Planning and Development Services Division Public Hearing Report

- Meeting Date:** September 12, 2016
- From:** Cecilia A. Hernandez - Project Planner
- Location:** Southwest of the intersection of South Woods Mills Road and Brookings Park Drive (18Q140361, 18Q140370, 18Q140352, 18Q140077).
- Petition:** **P.Z. 07-2016 Willows at Brooking Park (Amendment to CUP #31)**: A request to amend Conditional Use Permit (CUP) #31 to amend the development conditions in an “R-1” Residence District, “R-3” Residence District, and “FPR1” Flood Plain Residence District for a 26.65 acre tract of land located southwest of the intersection of South Woods Mill Road and Brookings Park Drive. (18Q140361, 18Q140370, 18Q140352, 18Q140077).

Willows at Brooking Park has submitted a request to amend existing the Conditional Use Permit (CUP) #31 in order to: modify the number of seats in their private club restaurant facility, change the structure setback along a portion of the southern boundary, and change the parking setbacks along the eastern and a portion of the southern boundary lines.

Figure 4. Land Use Plan

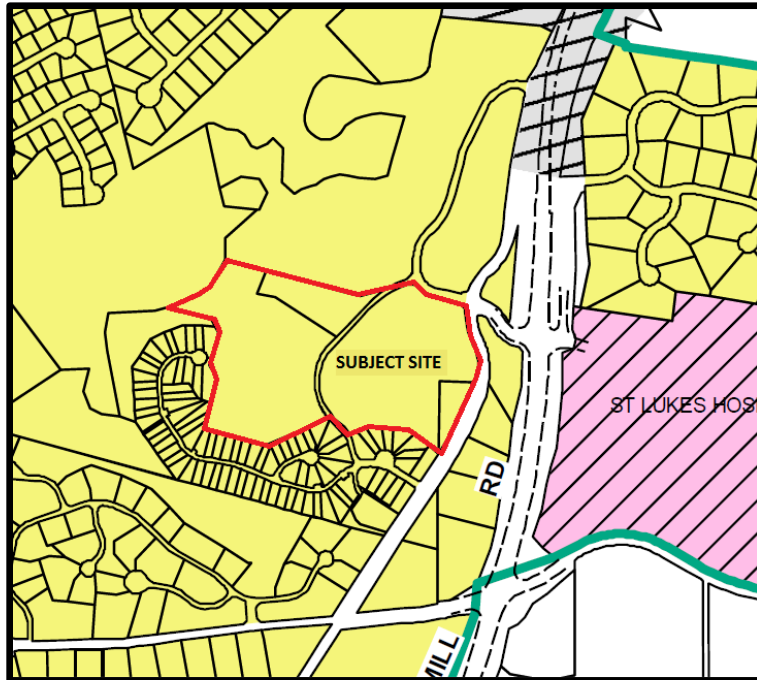
In addition to the Land Use designation, the Comprehensive Plan also included the following policies which would apply to this proposal:

- **2.1.5 Provide Buffer for Existing Residential Development-**
New higher density residential development and non-residential development adjacent to existing residential subdivisions should provide for a substantial landscape buffer and landscaped area between the uses so as not to alter the conditions and environment of existing residential neighborhoods.

The existing CUP as well as City Code requires that landscape buffering be provided between this development and neighboring developments. There is currently a large Greenspace Preservation area that is in place along the northwestern portion of the site, where the FPR1 Zoning District is in place. Additionally, staff recommends that either a 6' sight proof fence be erected along the southern perimeter of the site, or a more densely vegetated buffer be installed along lots 14 through 27 of the Terrace at Woods Mill Cove subdivision. This language will be included in the CUP presented at the vote meeting. These requirements will ensure that a buffer is provided between the subject site and surrounding developments to address policy 2.1.5.

Figure 3. Existing structure in legal non-compliance

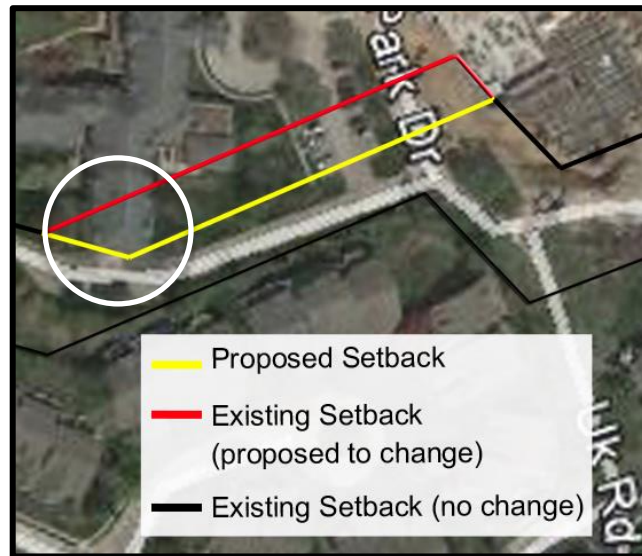
2. **Structure Setbacks-** The structure setback is requested in order to bring an existing building into compliance (pictured below in Figure 7). No site changes are shown of the Preliminary Plan for this area. In 2008, when the amendment to the original CUP was passed, there was a more restrictive setback placed than the 1989 CUP. The 2008 amendment to the CUP therefore placed this building into non-compliance.

There are additional restrictions for nursing homes as part of the underlying “R-1” and “R-3” Residential District regulations, one of which is that no structure shall be within fifty (50) feet of any property line. There are no amendment requests at hand which would impede on this requirement. Staff has no concerns regarding this change.
